## PCN (Product Change Notice)

| <b>PCN Number:</b> PCN_IndHCMD_20251010<br><br><b>Affected Series:</b> WE-HCMD<br><br><b>Affected Part Number:</b> see table "PART NUMBER, REVISION & DATASHEET"<br><br><b>PCN Date:</b> 2025-07-10 (YYYY-MM-DD)<br><b>Effective Date:</b> 2025-10-10 (YYYY-MM-DD) |  | <b>Change Category:</b><br><input type="checkbox"/> Equipment/Location<br><input checked="" type="checkbox"/> General Data<br><input type="checkbox"/> Material<br><input type="checkbox"/> Process<br><input type="checkbox"/> Product Design<br><input type="checkbox"/> Shipping/Packaging<br><input type="checkbox"/> Supplier<br><input type="checkbox"/> Software |

**DESCRIPTION OF CHANGE:**

##### Alteration (1):

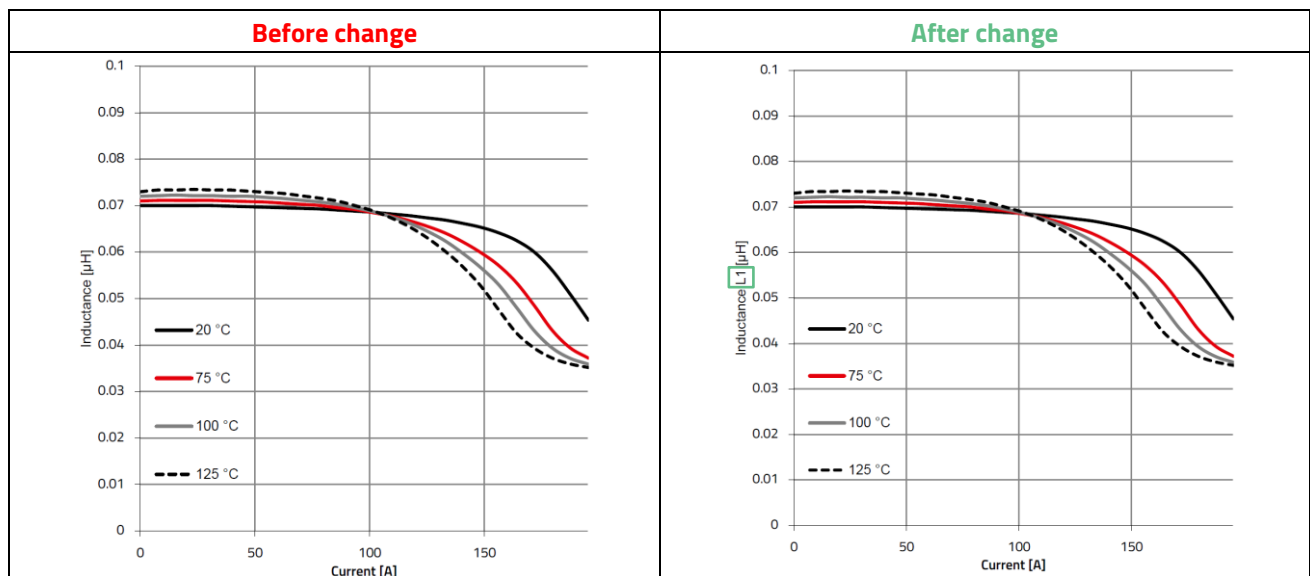
The AEC-Q200 qualification has been conducted to enhance product reliability and is presented as following in the datasheets:

| Before change                                                                                                                                                                                                                                                                                                                     | After change                                                                                                                                                                                                                                                                                                                                                                                                                              |                                 |                |                                     |              |                        |              |                          |                                                                                                                                                                                                                                                                                                                                                                                               |               |                                 |                |                                     |              |                        |              |                          |                         |          |
